Comments on the Applicant's D6 submissions

This document sets out the comments on the Applicant's Deadline 6 (D6) submissions by Cambridgeshire County Council (**CCC**), Huntingdonshire District Council (**HDC**) and South Cambridgeshire District Council (**SCDC**) (together, the **Councils**). The tables below set out the document in question that the Councils are commenting on, together with the relevant paragraph or reference number.

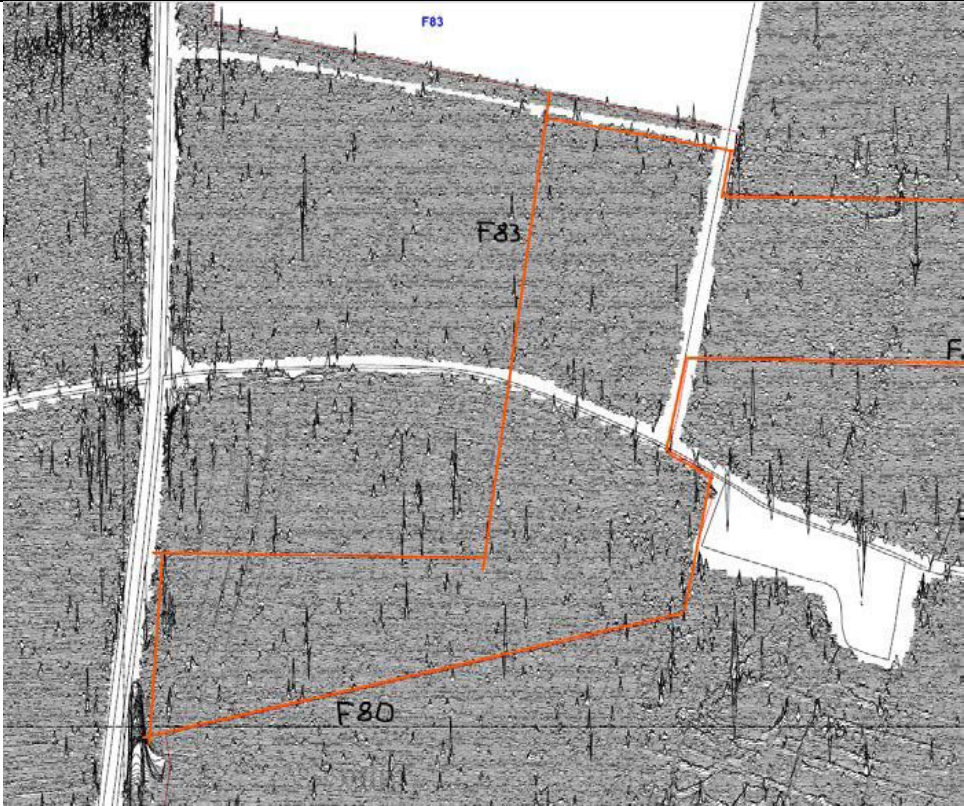
Topic	Paragraph Number	Councils' Comment
<p>REP6-047 Fig 9.87</p>	<p>Sheet 10/41</p>	<p>The excavation boundary is too tight to Iron Age enclosure boundary and the limit of excavation does not reach the brook south of Trenches 538 and TR284. This proposal does not conform with the requirements of the LA archaeology brief and the area should be expanded to that advised by CCC below.</p> <p>Site 10 CCC area:</p> 
<p>REP6-048 Fig 9.87</p>	<p>Sheet 11/41</p>	<p>CCC had advised the Applicant to expand the excavation area within the Orders Limits to include anticipated remains associated with broader series of enclosures (shown as blue lines) that occur to the immediate north west of but within the Orders Limits and that might extend into the Scheme area. This would provide an adequate zone for investigation around the enclosures where unenclosed occupation tasks were carried out. The investigation should allow connectivity of the known sites and investigate areas where no survey data is present (white zones).</p> <p>Site 11 CCC area below:</p>

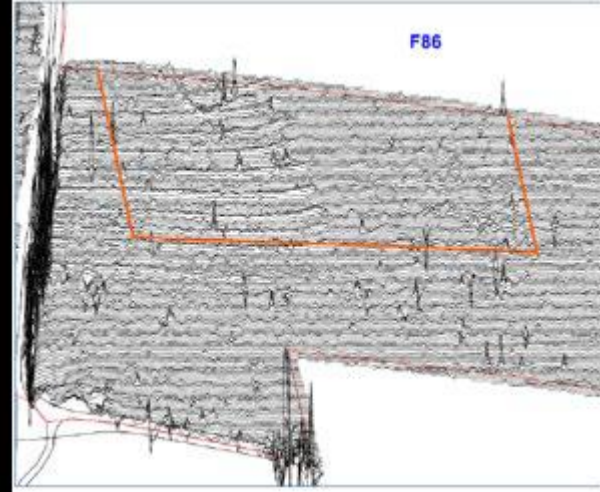
<p>REP6-048 Fig 9.87</p>	<p>Sheet 12/41</p>	<p>The box around Tr122 is the minimal area of exclusion. CCC had recommended extension to just north of Tr129, to exclude the boundary and anticipated associated features of the Iron Age site lying mostly to the east of the Orders Limit.</p>	
<p>REP6-048 Fig 9.87</p>	<p>Sheet 13/41</p>	<p>This area suitably buffers the square Iron Age enclosure and is agreed.</p>	
<p>REP6-048 Fig 9.87</p>	<p>Sheet 14/41</p>	<p>This area is in the A428 compound in the Wintringham Park development area and has been excavated by archaeologists appointed by Urban and Civic (the developer). A Late Bronze Age cemetery was found - unexpected as there are no known contemporary settlements in the area, extending the occupation on the clay here back in time. As Site 14 has been excavated under the remit of another development, it does not need to be</p>

included in the list of A428 sites and could be removed, thereby reducing the number of sites that the Applicant is directly responsible for.
REP6-048 Fig 9.87	Sheet 15/41	This is the agreed minimum area for excavation of this Roman site related to a villa immediately west of the Orders limits.
REP6-048 Fig 9.87	Sheet 16/41	Two mitigation types are shown: the yellow-edged box on the new track is the agreed minimum area for excavation of Iron Age and Roman remains at Site 16, the majority of which (purple dashed box) will be fenced off and protected within the Orders Limits as agreed.
REP6-048 Fig 9.87	Sheet 17/41	<p>This excavation area of this multi-period site is agreed, but has been assigned by the Councils for detailed excavation, not that which is outlined by the Applicant. Rarely are elements of Saxo-Norman settlement excavated in Cambridgeshire and they form a focus of the Regional Research Agenda (shown as REF 19 in [REP4-031, 1.7.3 a]), and see REP4-031 4.4.22 a asserting the importance of investigation of settlement from this date.</p> <p>We do not accept the mitigation strategy put forward in REP4-031 p.189. It is too selective and impossible to implement as previously outlined in our Written Representation REP1-048 and REP4-060 (responding to REP1-048cf 12.2.3a). We emphasise the need to follow the excavation methods provided in section 6 the Joint Authorities' Archaeology Brief shown in Appendix B of REP4-031.</p> <p>The site occurs to the east of Site 35 (REP6-050 Fig 9.87 Sheet 35/41).</p>

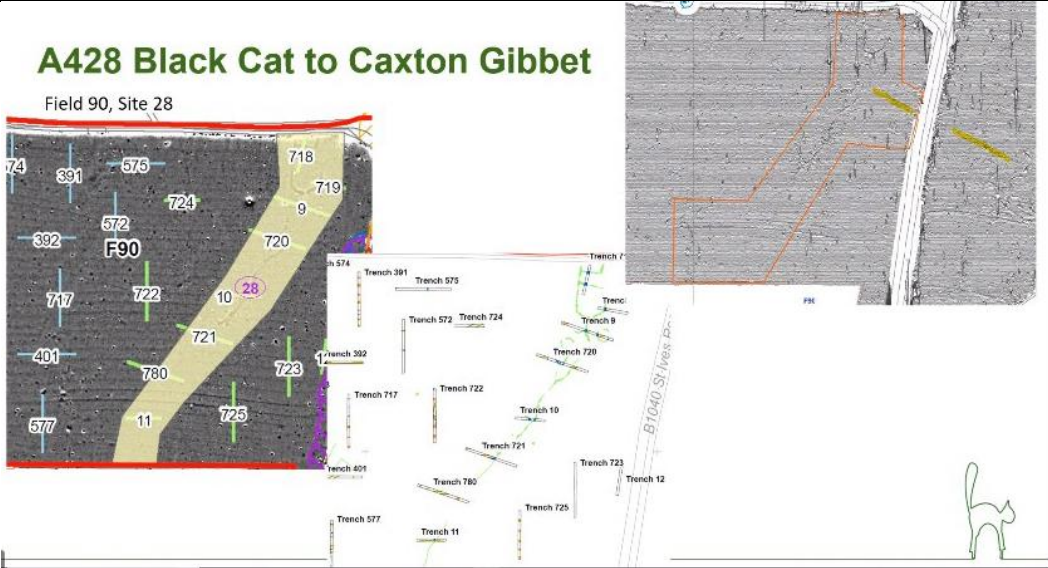
REP6-048 Fig 9.87	Sheet 18/41	The area lies to the north of Wintringham Deserted Medieval Village (Historic Environment Record ref MCB1642), the southern part of which is scheduled (NHLE ref 1006815). The area shown on the west of the plan, for Field 73 is agreed, along with the strategy for excavation for this multi-period site. We emphasise the need to follow the excavation methods provided in section 6 the Joint Authorities' Archaeology Brief shown in Appendix B of REP4-031.

<p>The Councils do not agree with the area for excavation shown in Field 74 to the east of F73 as this excludes known archaeological remains outside archaeological enclosure boundaries in this zone (unenclosed activity).</p> <p>Site 18 CCC area is shown outlined in orange below:</p>  <p>The Councils have taken a pragmatic approach to this area by reducing their orange outline to the minimum area buffer around the known remains, rather than requiring all of Field 74 to be excavated. This advice has been consistent since initial discussions on the mitigation strategy held in September 2020.</p>
<p>REP6-048 Fig 9.87</p>	<p>Sheet 19/41</p>	<p>This excavation area is not agreed as it fails to adequately incorporate the northwest-southeast zone of archaeological sites south of Hen Brook where they extend into the Scheme (shown as blue lines outside the Orders Limits to the west). The excavation area should include the ring ditch of a building (unenclosed activity) shown in red below and at the east end of Tr1214 on the Applicant's map. We emphasise the need to follow the excavation methods provided in section 6 the Joint Authorities' Archaeology Brief shown in Appendix B of REP4-031.</p> <p>Since last presenting this map to the Applicant on 30 June 2021 for a SoCG meeting, we note that the area along Hen Brook to the northwest will be included in the DCO for</p>

CCC Site 34 recommended area is outlined in orange below:

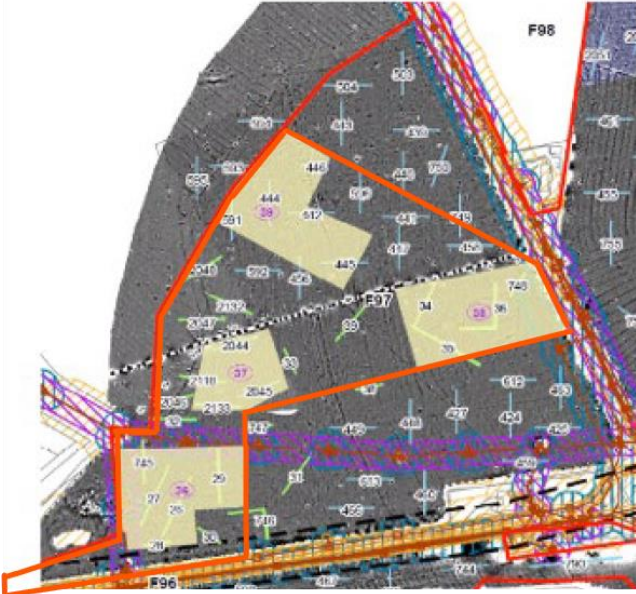
<p>REP6-050 Fig 9.87</p>	<p>Sheet 34/41</p>	<p>The archaeological site found in this field to the northwest of Pastures Farm and Caxton Gibbet fills the entirety of Field 95 and extends west of the western field boundary into Field 94 (shown as pink features in trenches), especially in the NE corner. There are a number of Iron Age settlement enclosures with external activity area between this part of the road scheme and Caxton Gibbet roundabout and constitute a settlement landscape.</p> <p>The whole scheme area in this field should be stripped (in stages if necessary for spoil management), and subject to archaeological investigation prescribed in Section 6 of the</p>

Joint Authorities' Archaeological Brief (Appendix B, REP4-031), in part to address the need to establish the antiquity of the road to St Neots – believed to be a Roman Road and therefore likely to have had a junction with Ermine St to the east of that and also formed a hundred boundary and line of Cambridge Road. The entirety of this field should be excavated up to the current road and extend west into Field 94 and the northwest corner of F96.
